October 25, 2022

North Yarmouth Planning Board
10 Village Square Road
North Yarmouth, Maine

Re: Updates to Proposed Village Green Apartments, Walnut Hill Road

AMENDED SUBDIVISION PLAN
 LOT 23, VILLAGE CENTER ESTATES
 WALNUT HILL ROAD - NORTH YARMOUTH MAINE
 OWNER OF RECORD
CONSTRUCTION AGGREGATE, INC.
 NORTH YARMOUTH, MAINE

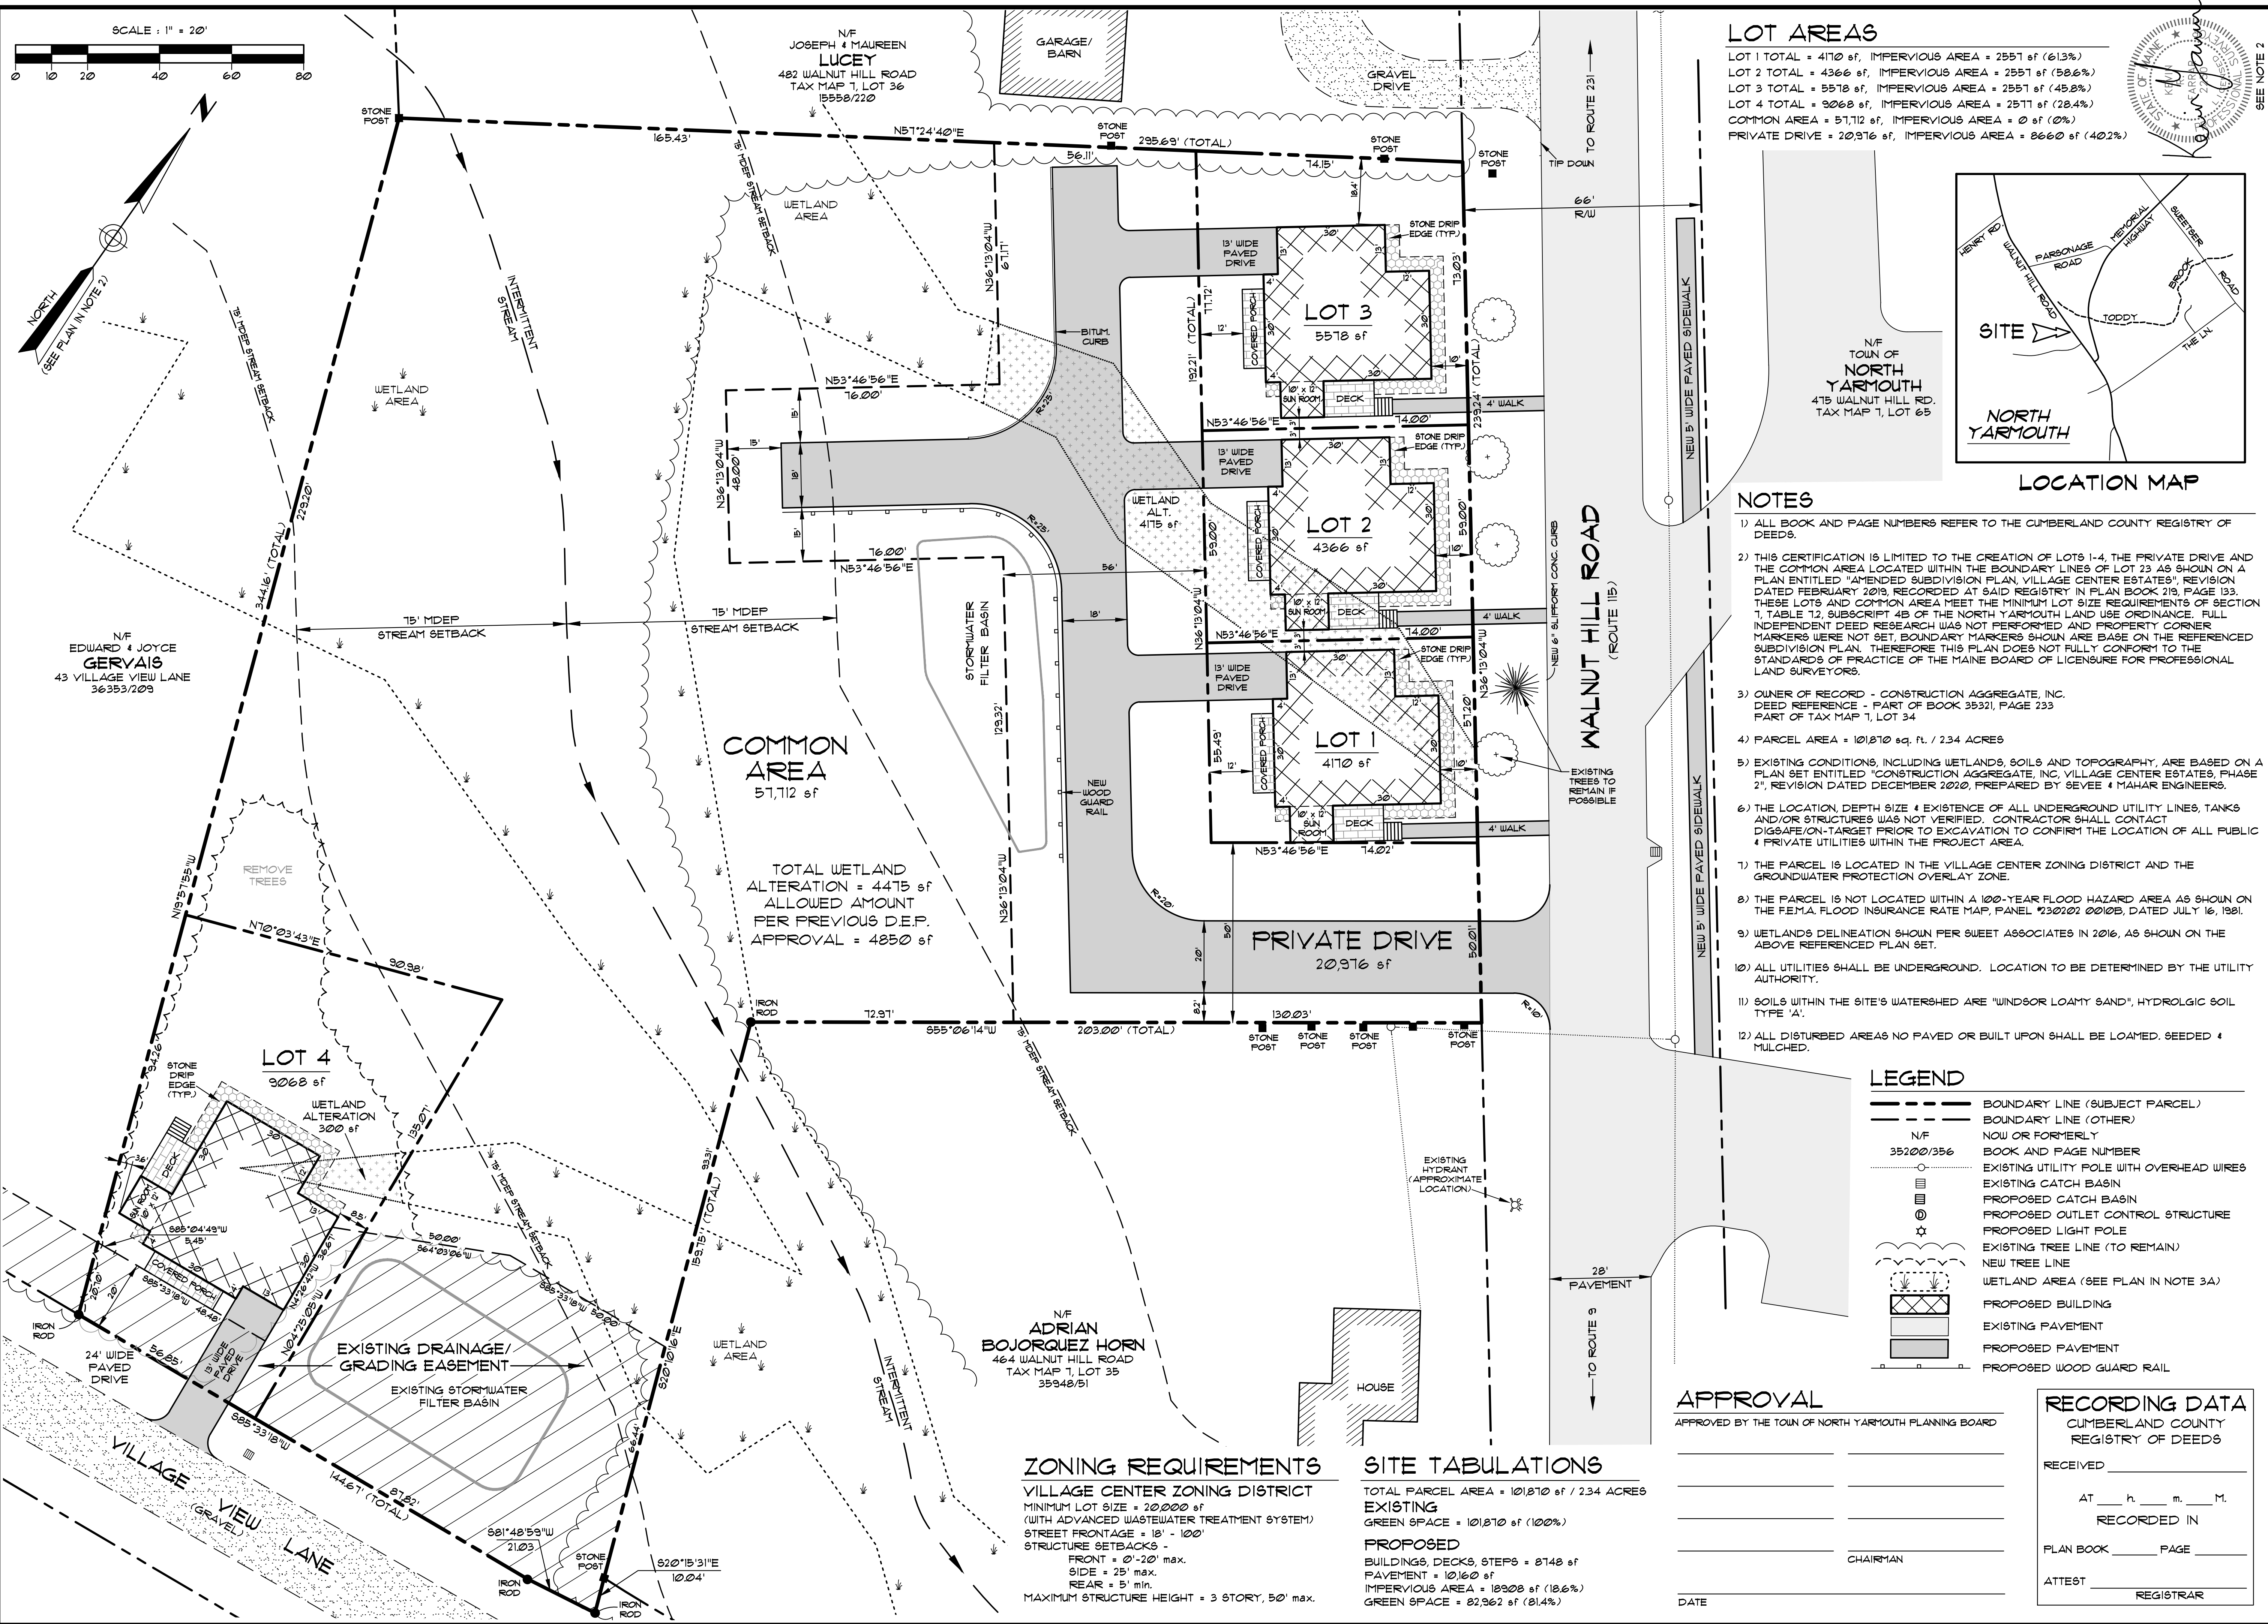
2	SJR	10-16-2022	MOVE BUILDINGS 2 & 3 ADJUST LOTS 1-3
1	SJR	10-6-2022	BOUNDARY CHANGE, LOTS 1-3 AND PRIVATE DRIVE
	REV. BY:	DATE:	CHANGES:

TOPOGRAPHIC SITE PLAN
 LOT 23, VILLAGE CENTER ESTATES
 VILLAGE GREEN APARTMENTS
 WALNUT HILL ROAD - NORTH YARMOUTH MAINE
 PREPARED FOR
CONSTRUCTION AGGREGATE, INC.
 NORTH YARMOUTH, MAINE

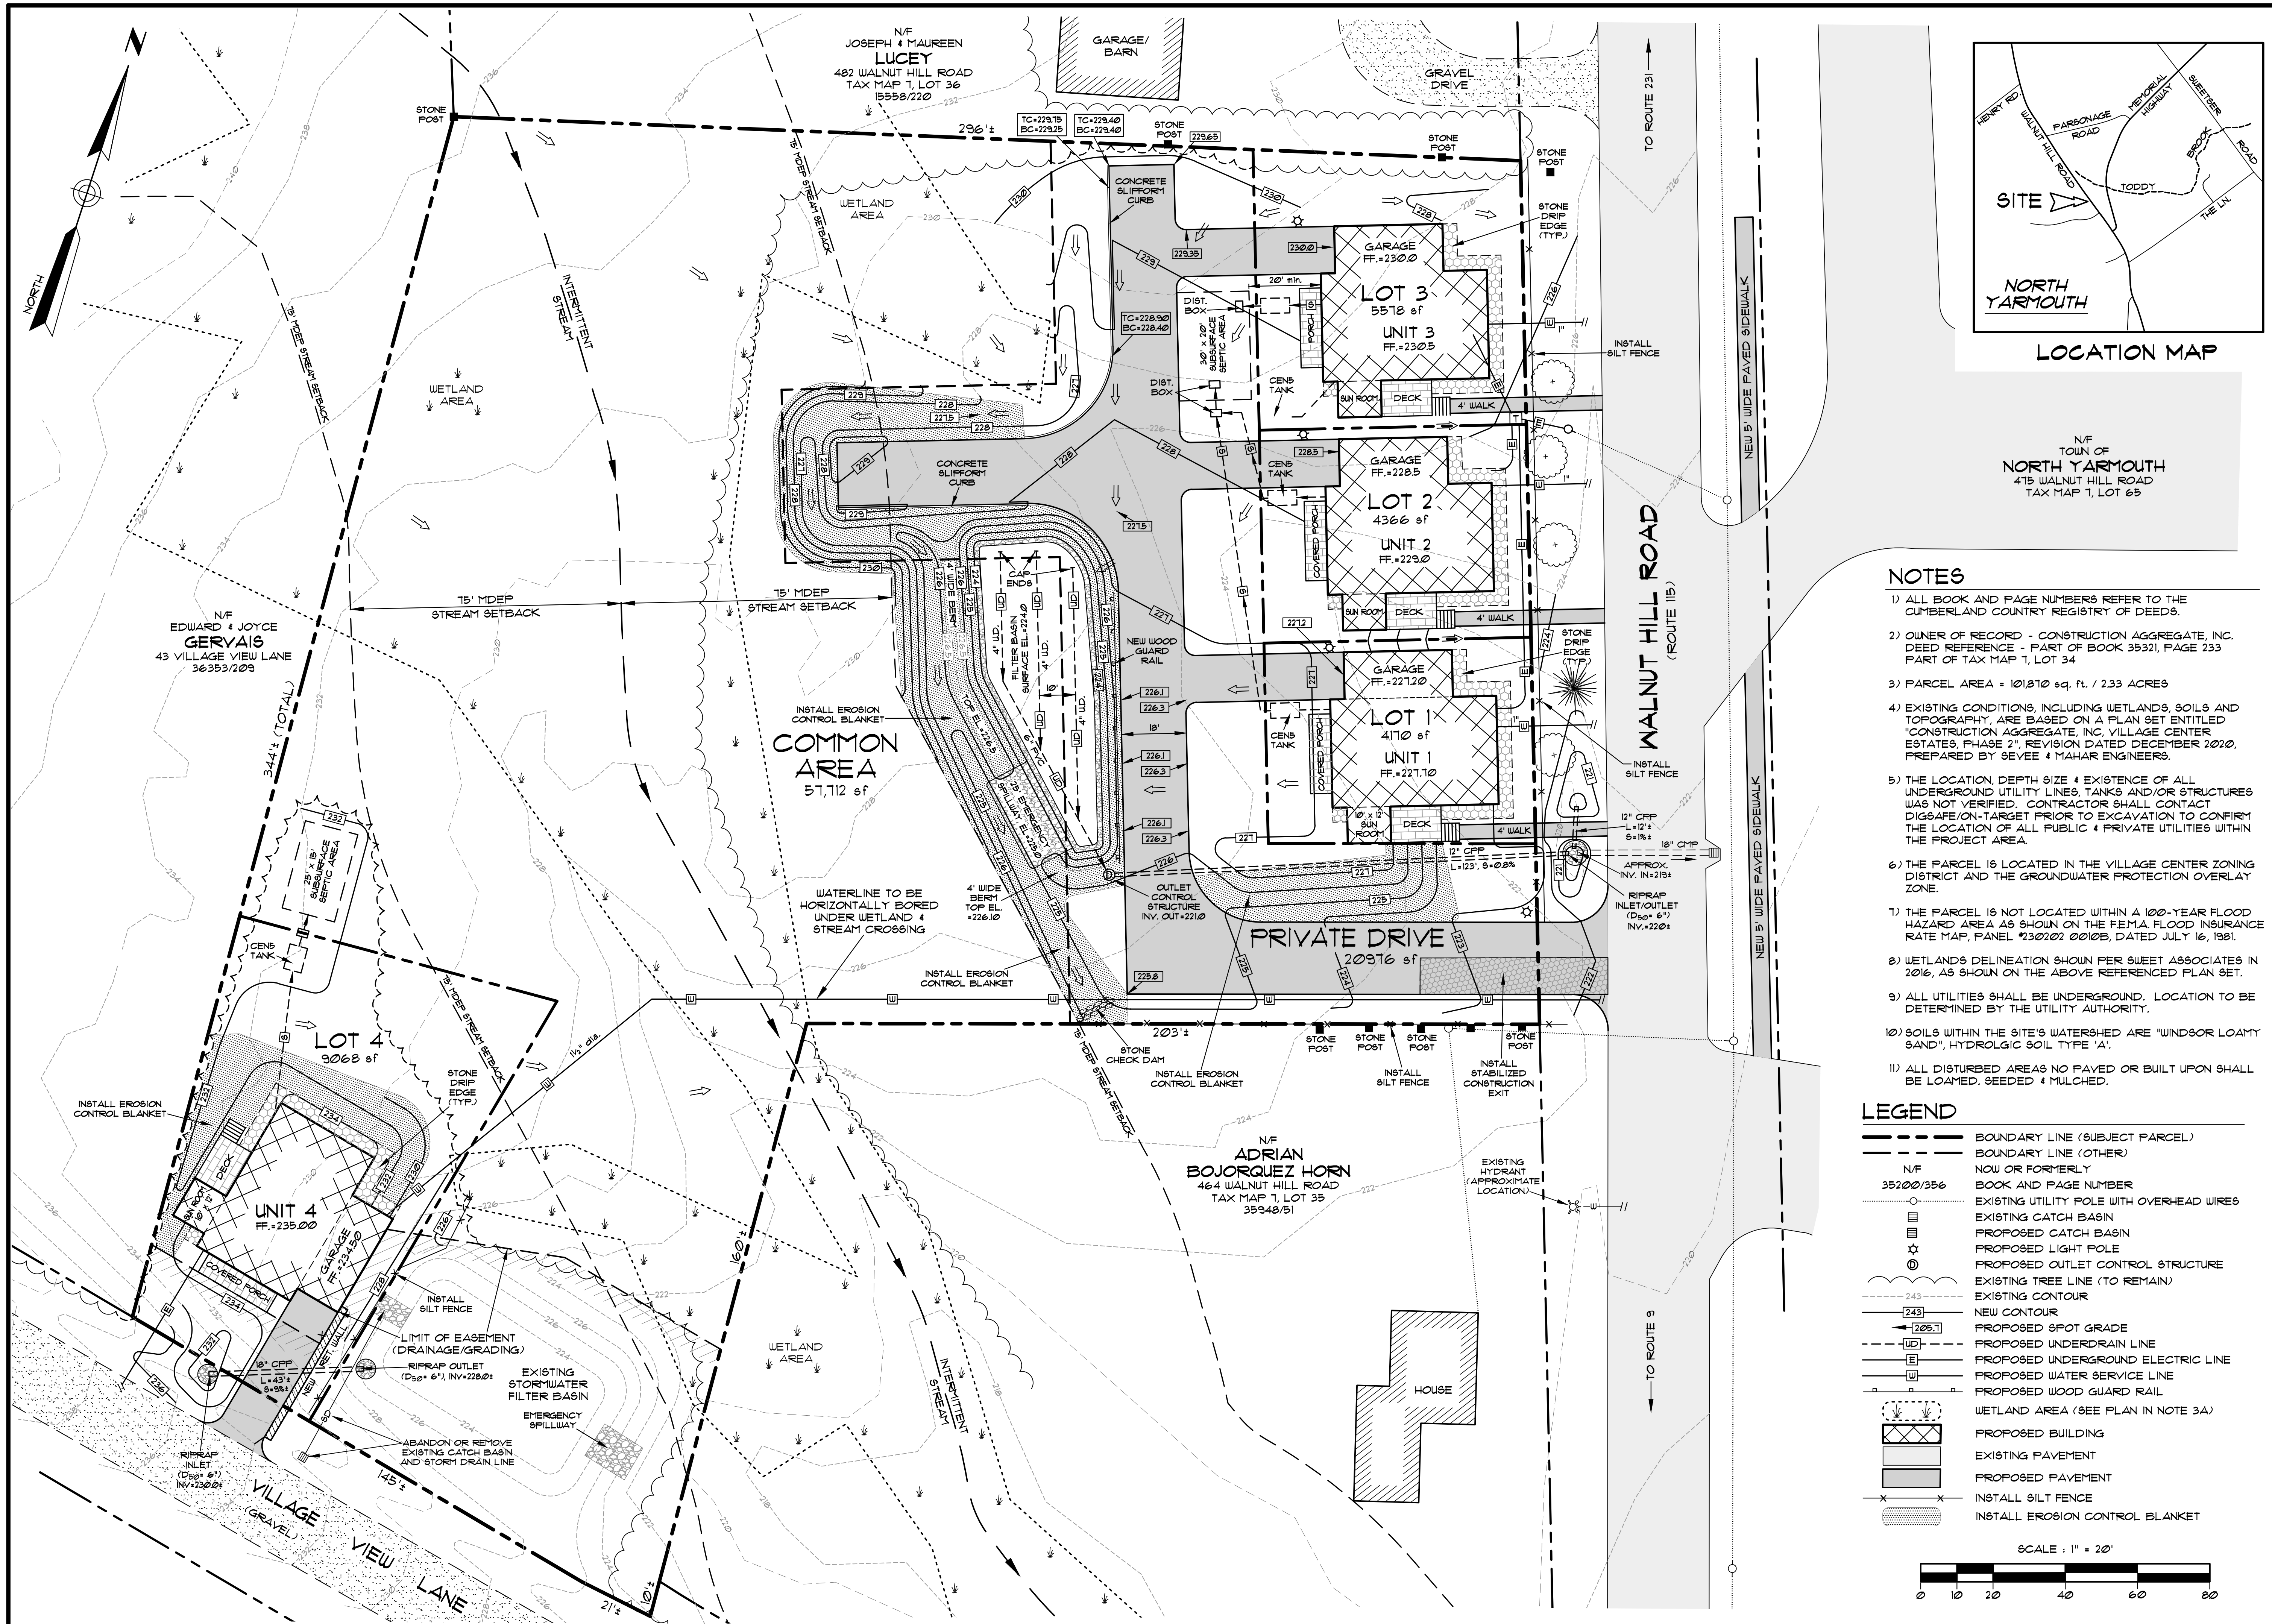
As noted above, there were several comments pertaining to proposed location for sidewalk construction. Ben Grover has spoken with the Public Works Director and has agreed to relocate the sidewalk to the Fire Station side of Walnut Hill Road rather than in front of the proposed development. This accomplishes several concerns with regard to drainage (see above) and saving trees along Walnut Hill Road ROW.

REV.	BY:	DATE:	CHANGES:
2	SJR	10-16-2022	RECONFIGURE LOTS 2 AND 3
1	SJR	10-6-2022	RECONFIGURE SEPTIC SYSTEM
